NONCONFORMANCE - REPORT LOG & STATUS BOOK

1. PROJECT NO. 7220

PROJECT NAME ¹ Midland 1 & 2 JOB NO. ¹ 7220 PAGE ⁸ 44

NCR 517
4 of 78 ^{RDS} 12/1/56

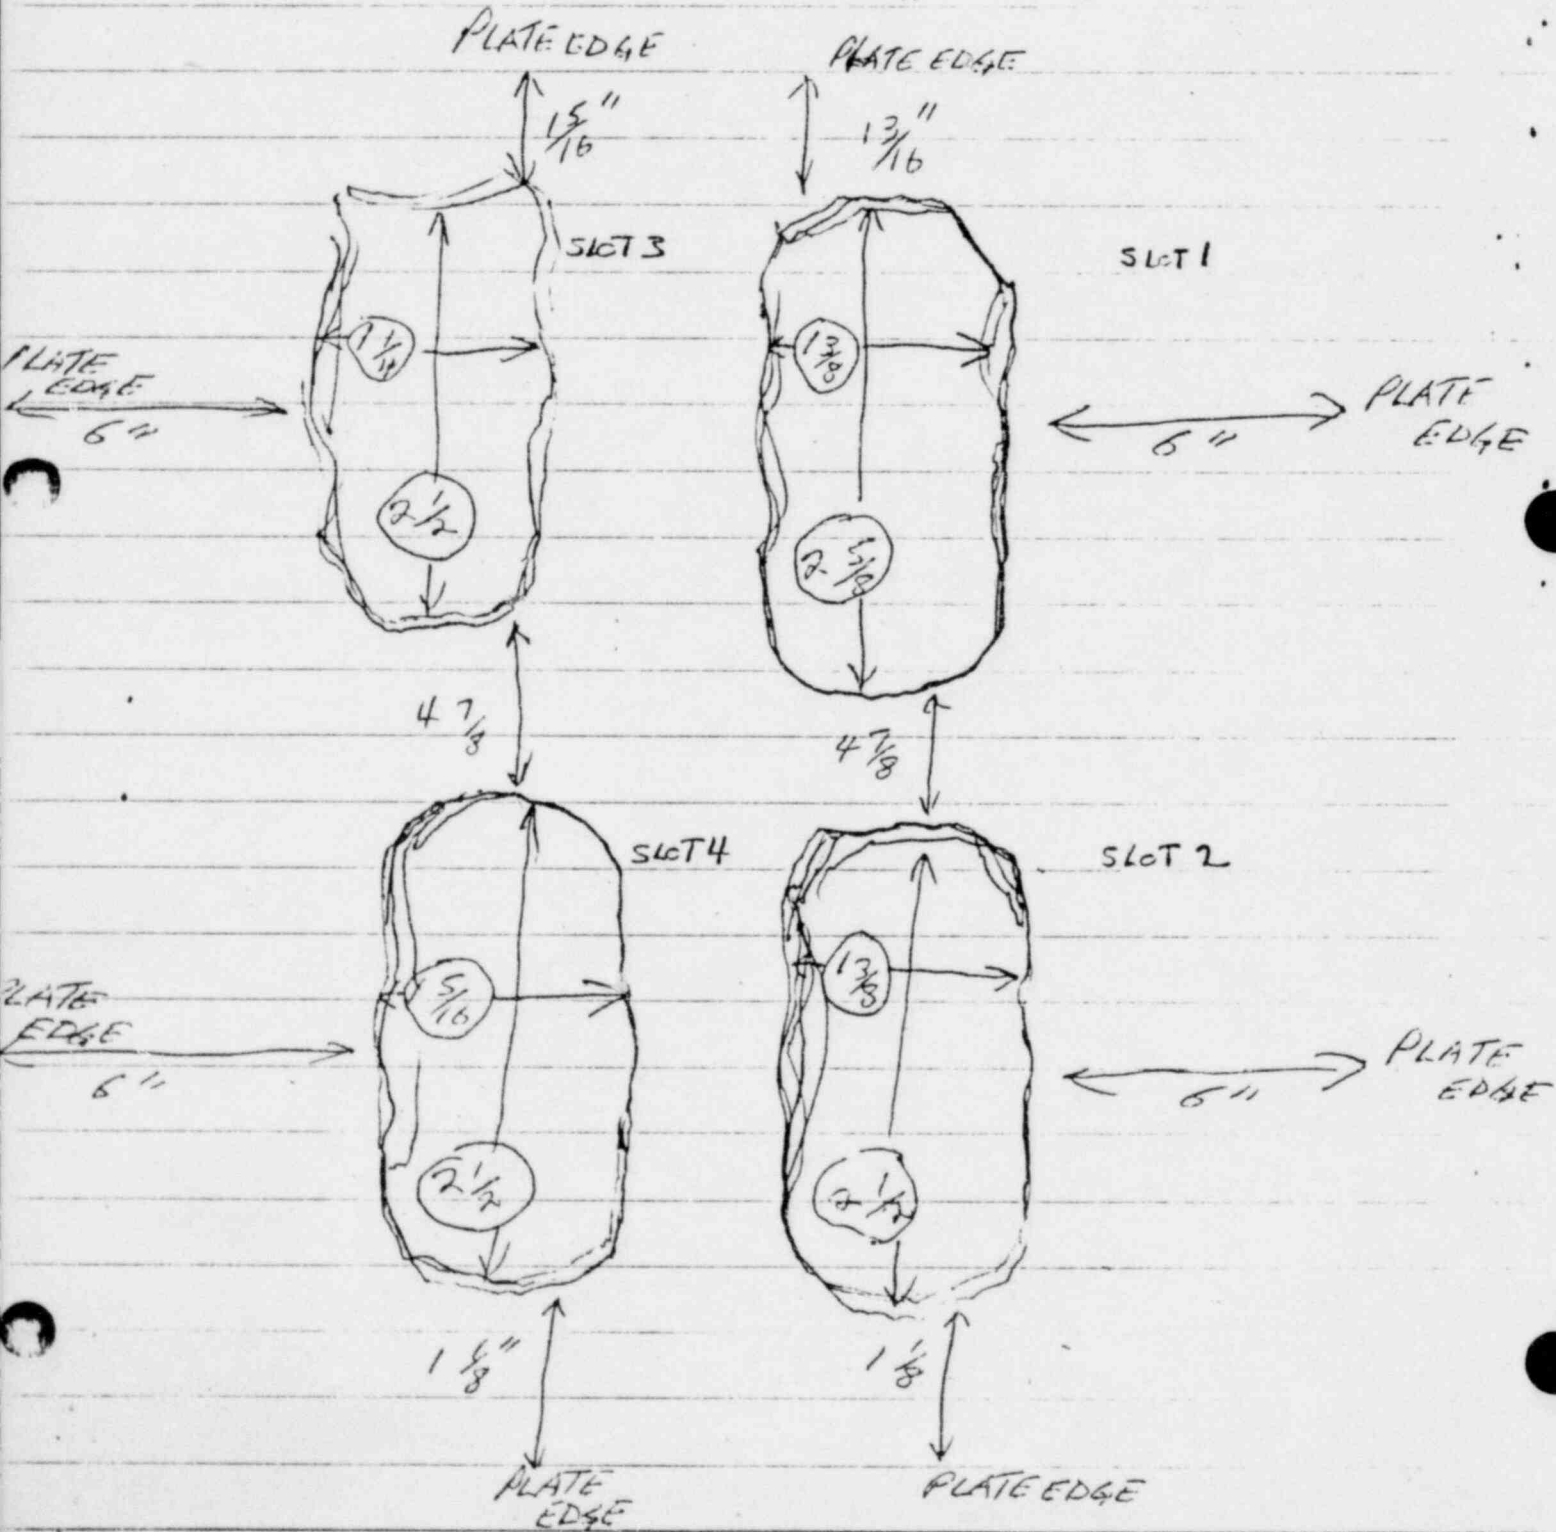
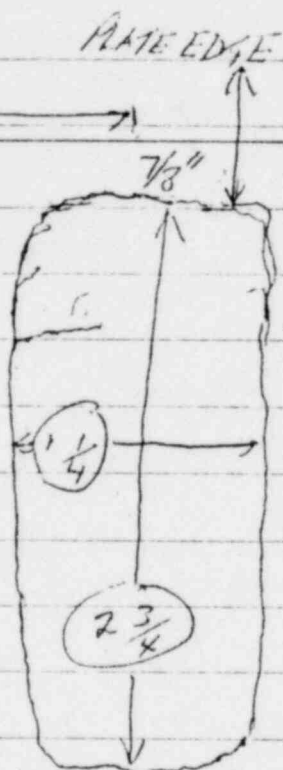
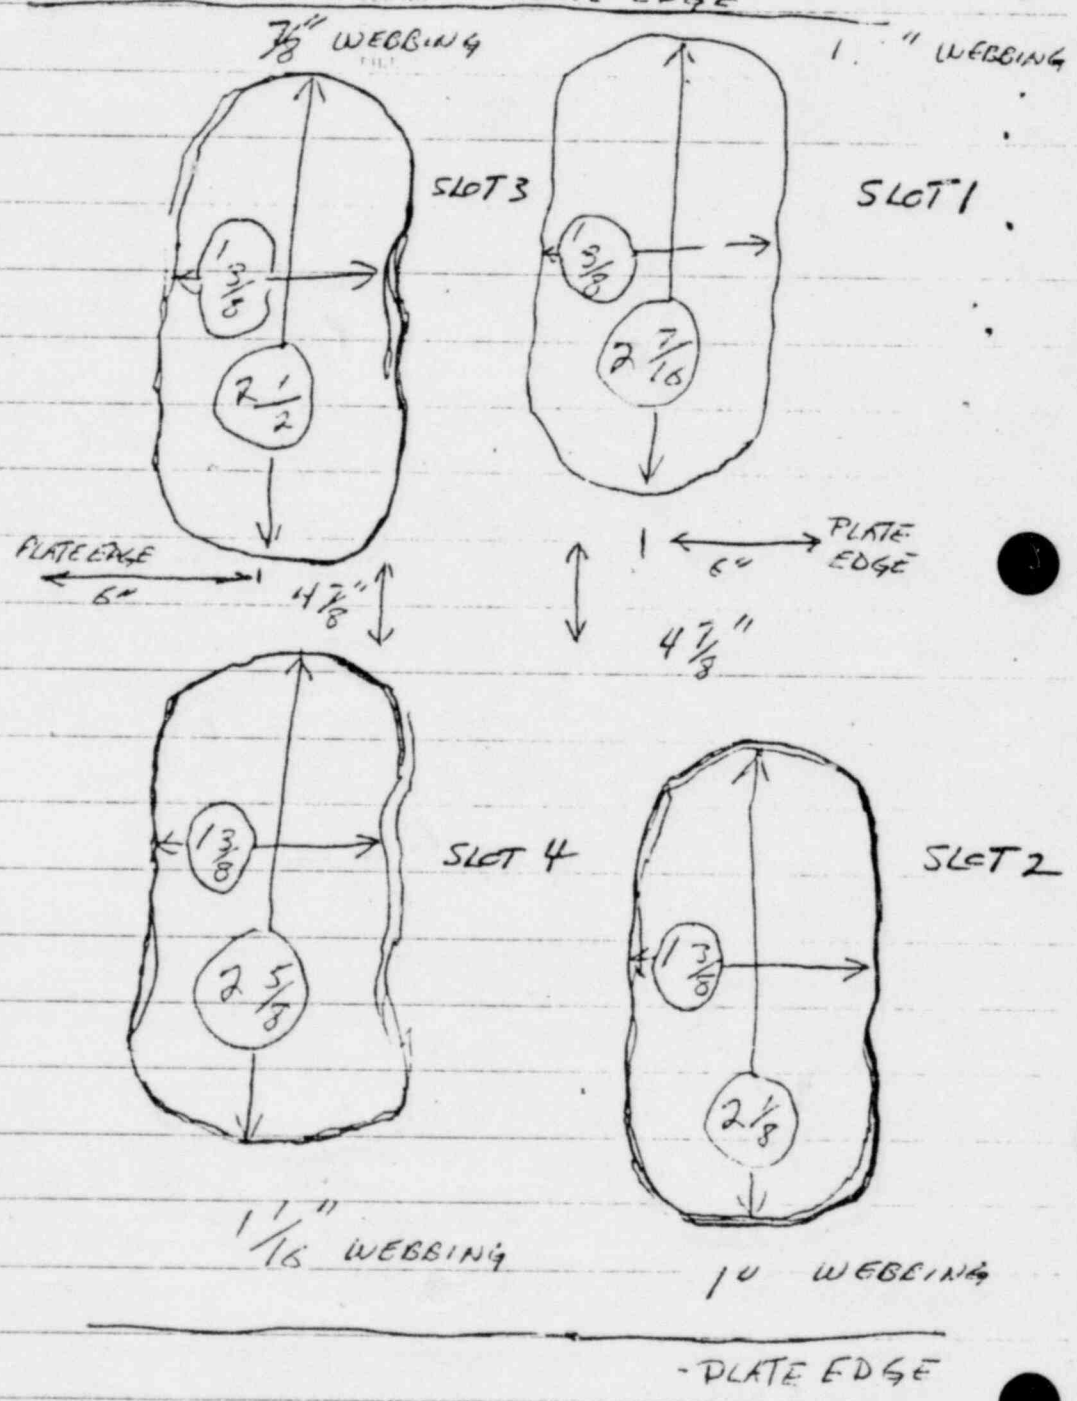
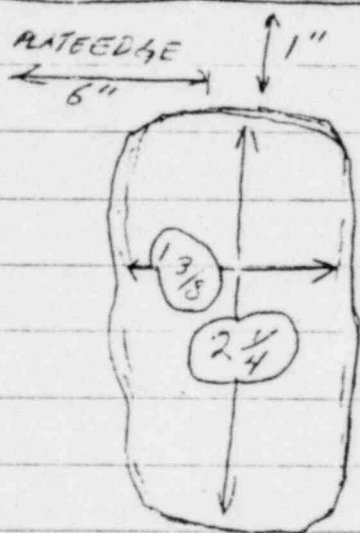
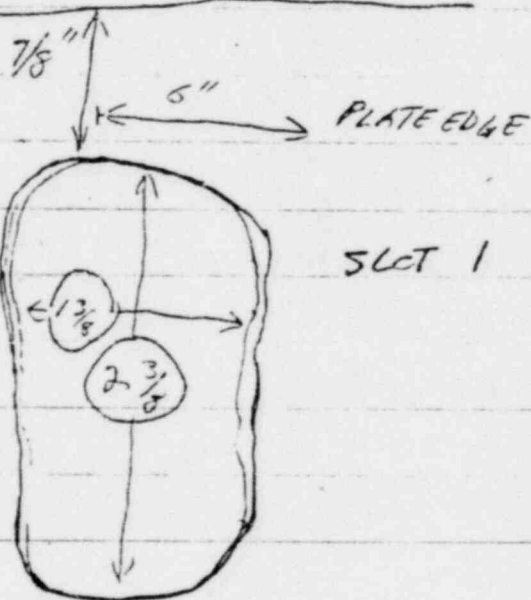
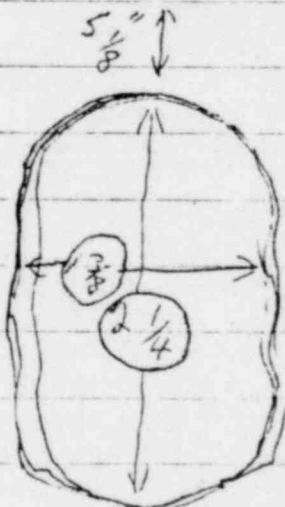
16. Nonconforming Condition: Slotted Support Feet of Decay Heat Removal Heat Exchangers as furnished do not agree in configuration or dimensions with details shown on Vendor Drawing ML.18-1-4 (Atlas Mfg. D-3287-6 Rev. 6) resulting in mismatch with slotted Flourogold Slide Bearing Assemblies. See attached sketches for dimensional discrepancies with Dwg. ML.18-1-4, Reference Dwg. C-195 Rev. 3 for details of Flourogold Assemblies. Four QC Hold Tags applied.			24. Disposition Concurrence REWORK REJECT REPAIR USE AS IS <input checked="" type="checkbox"/> REWORK

22. <input type="checkbox"/> Field Engineering Disposition <input type="checkbox"/> FIELD ENGINEERING RECOMMENDED DISPOSITION TO PROJECT ENGINEERING "The slots of the supports for the Decay Heat Coolers are to be reworked as necessary to meet the requirements of B&W drawing #02-520ND-06 (Atlas drawing #D3287-6, Rev. 6). The foundation slot holes are required to be in accordance with the drawing because of the expansion and contraction of the Cooler during heat-up and cool-down." (Ref: J. W. Marshall (B&W) to J. F. Newgen letter dated 11/30/76 attached.)			23. Project Engineering Disposition J.W. Marshall July 2, 12-2-76 M.H. Pooling 12/6/76

"The slots of the supports for the Decay Heat Coolers are to be repaired as necessary to meet the requirements of B & W drawing # 02-5204ND-06 (Atlas drawing " D3287-6, Rev 6). The foundation slot holes are required to be in accordance with the drawing because of the expansion and contraction of the Cooler during heat-up and cool-down"

531 - Pg 3 of 4
ATTACHMENT B

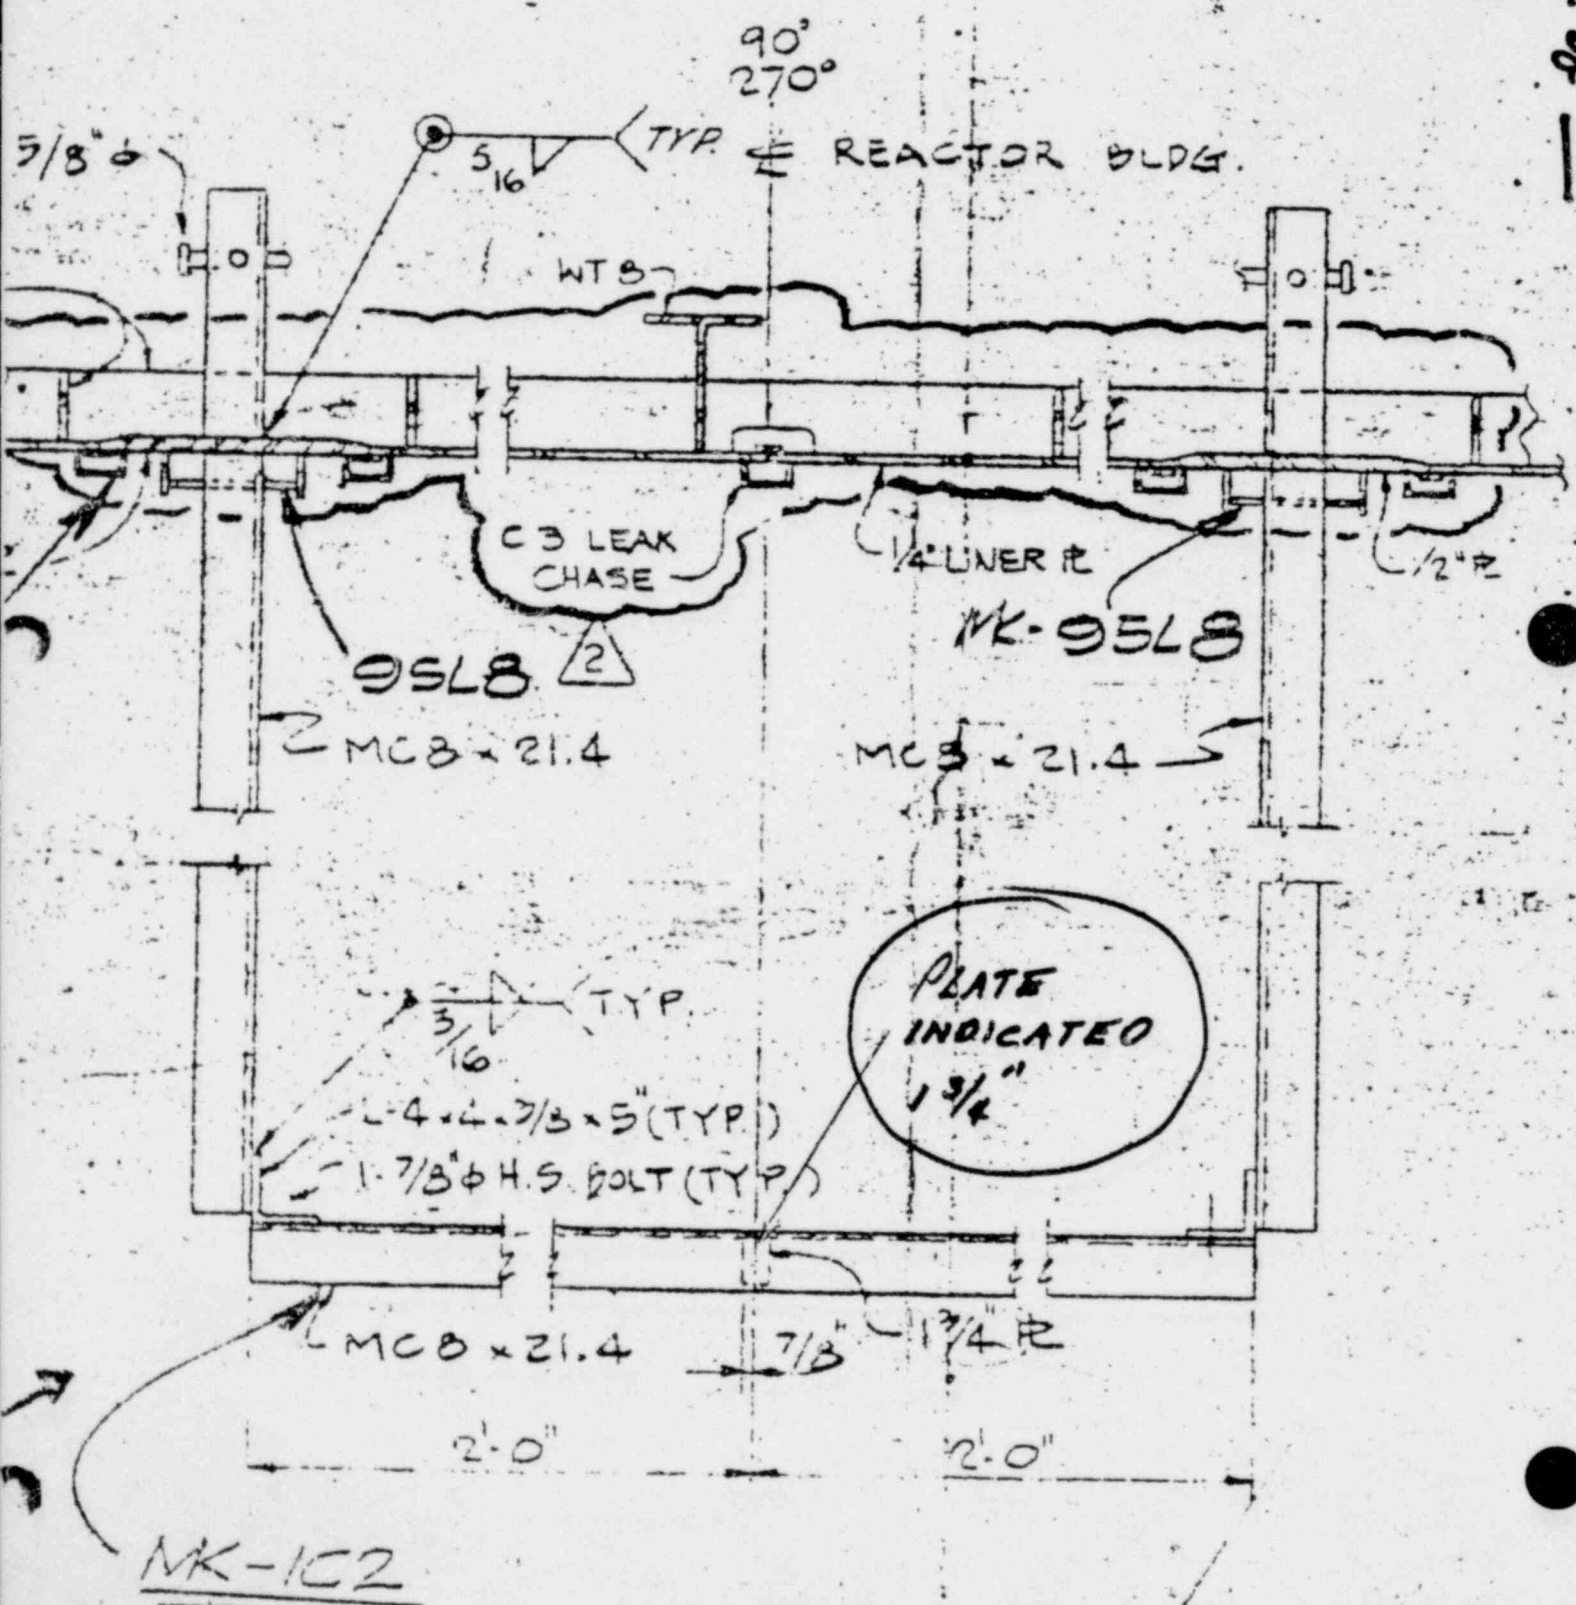
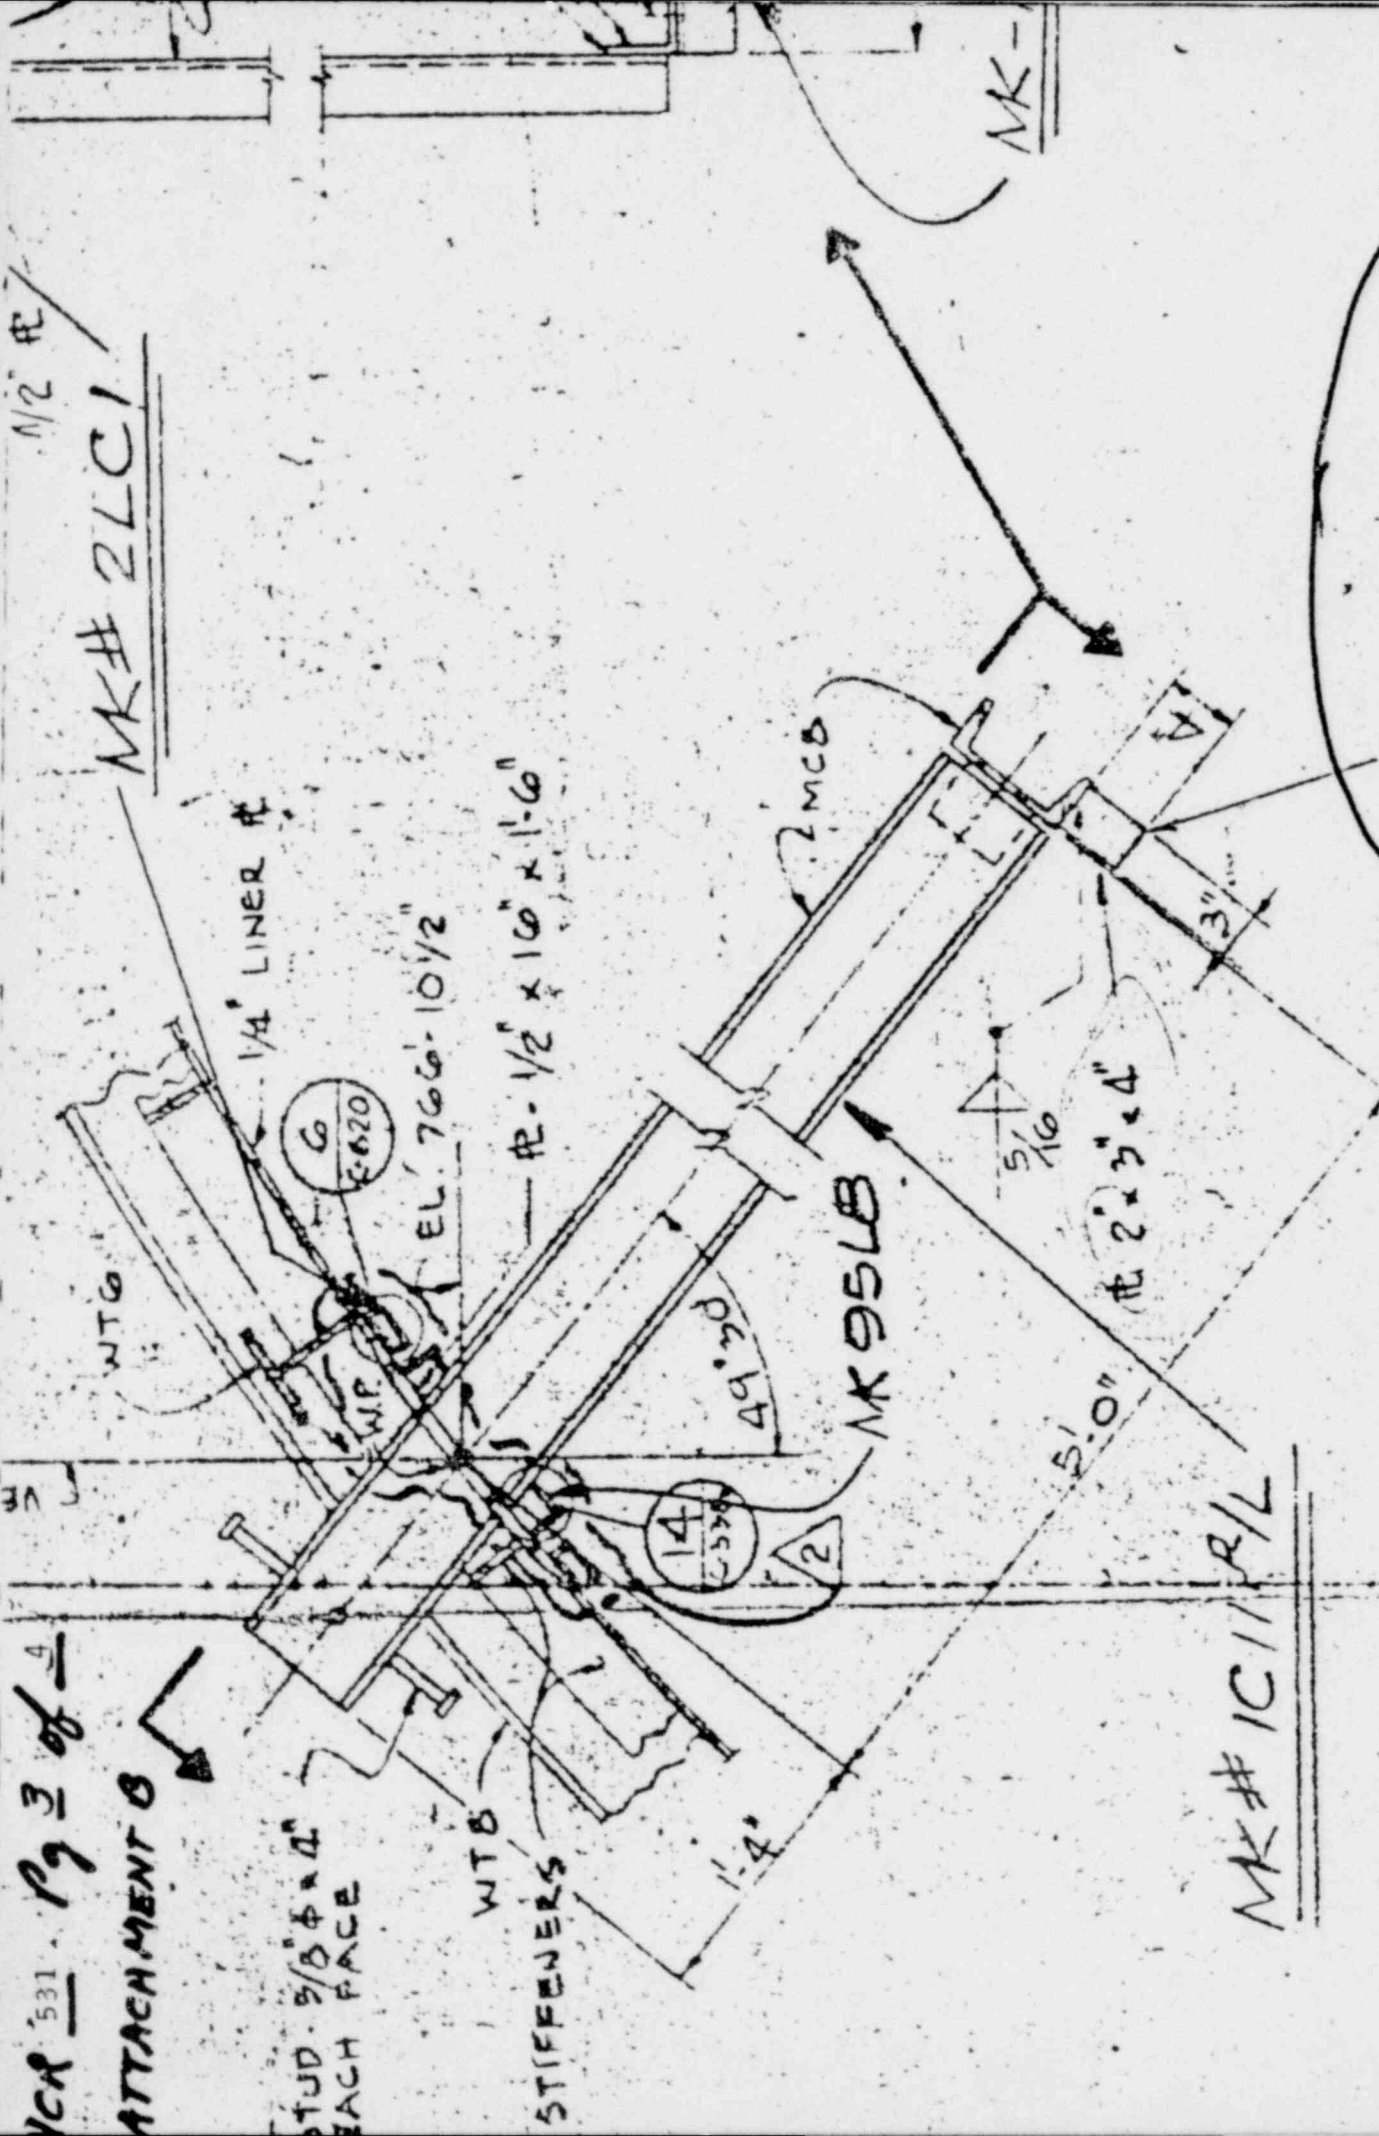
1. Project Name Midland		Job No. 7220		19. No. 531	20. Page 1 of 43	
2. Unit(s) Unit 2	3. Drawing/Part No. F7220-C233A-IR-E18-5	Rev 5	4. Item Description 2" x 3" x 4" Plate	5. Item Location QC Hold Area ^{PSM} 11/2/76

Block 22 revised:

The above described conflict on a vendor drawing reflects a conflict on the Bechtel Design Drawing #C-621. The material was purchased and received to the more conservative of two conflicting requirements, and is therefore acceptable. The design drawing will be revised to show the correct information.

A conditional release is authorized to continue installation. Drawing to be revised and NCR cleared prior to dome erection.
